REMARKS

Annotations to Annotated Marked-Up Drawings

Serial No. 09/834,059

FIG. 1

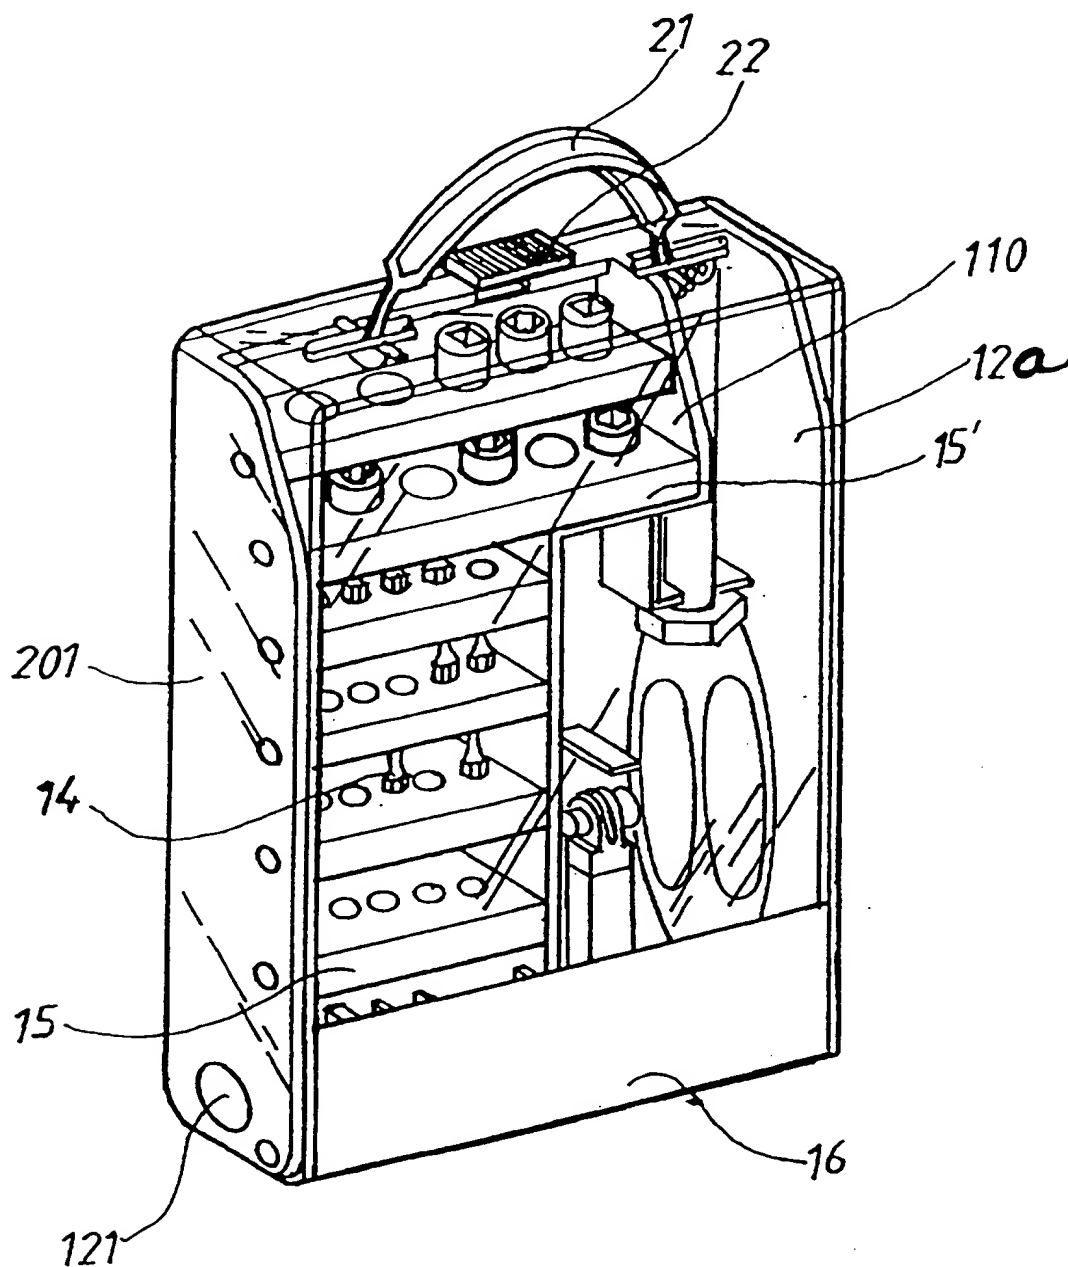
1. In FIG. 1, the reference numeral "12" is amended to "12a." This amendment provides a separate reference numeral for the right side (as viewed in FIG. 1) sidewall.
2. In FIG. 2:
 - a) The reference numeral "12a" is added to designate the right side (as viewed in FIG. 2) sidewall.
 - b) The reference numeral 13 designating an aperture in separating board 11 is amended to "13a." This amendment provides a separate reference numeral for the aperture in the separating board.

FIG. 3

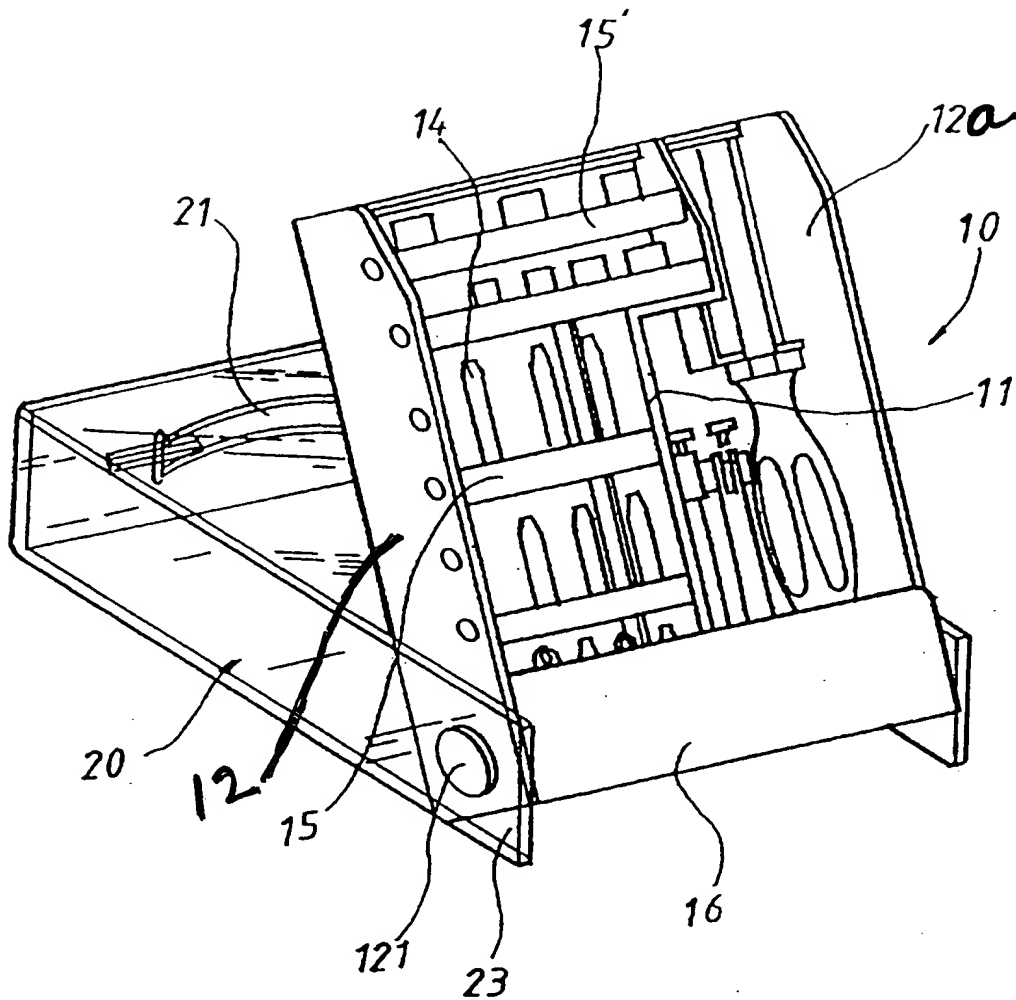
3. In FIG. 3:
- a) The reference numeral "12" is added to designate the left side (as viewed in FIG. 3) sidewall. This incorporates the reference numeral used for this sidewall in FIG. 2 into FIG. 3.

- b) The reference numeral "12" is amended to "12a." As set forth above, this provides a separate reference numeral for the right side (as viewed in FIG. 3) sidewall.
